April 13, 2023

RE: Draft Groundwater Protection and Well Monitoring Plan (the Draft Plan)
Highway 400 - Highway 404 Link (Bradford Bypass)

The Ontario Water Resources Act
WATER WELL RECORD

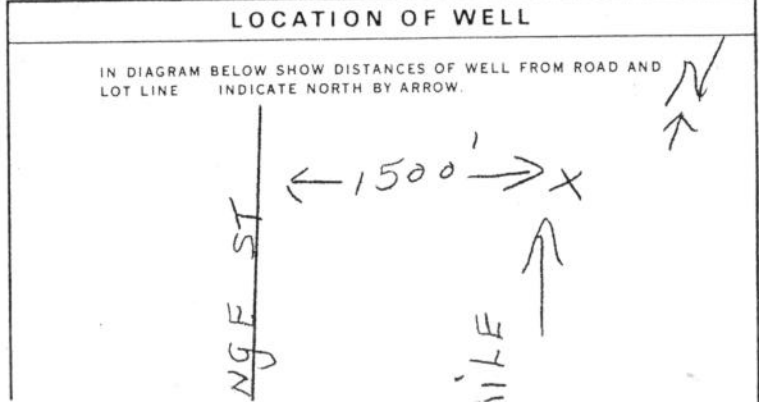
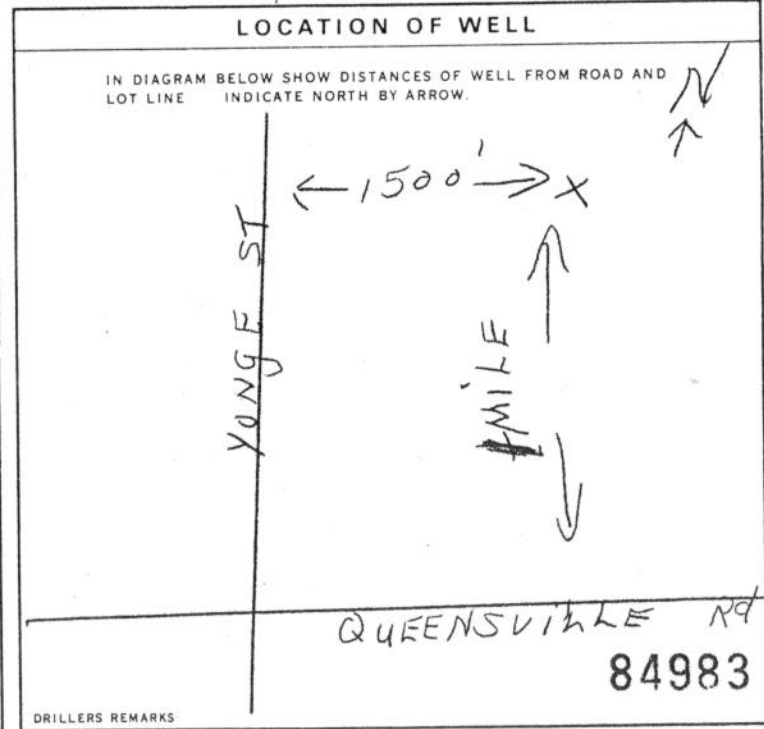
In closing, I have to question the accuracy of your private well information. I am one of the 17 responders mentioned above. Representatives from your corporation attended at my property, tested my well and subsequently sent me a report of their findings. At the time, they mentioned that my well was not included in their records. Based on your Draft Plan, this appears to still be the case. Enclosed for your records is both my official well record together with an updated map of well locations contained in your draft Plan.

AECOM	Figure 2d
--------------	-----------

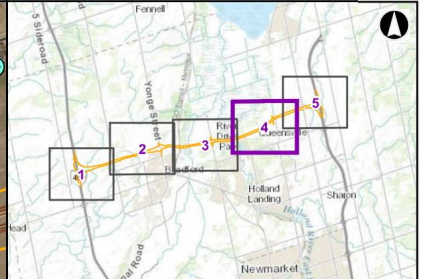
“As shown in Figure 2, there are potentially at least 260 domestic, livestock, commercial, industrial or public water supply wells within the Study Area and these **should be visited** prior to construction beginning to determine if the well is still used for the residence.”⁹ **[Emphasis added]**
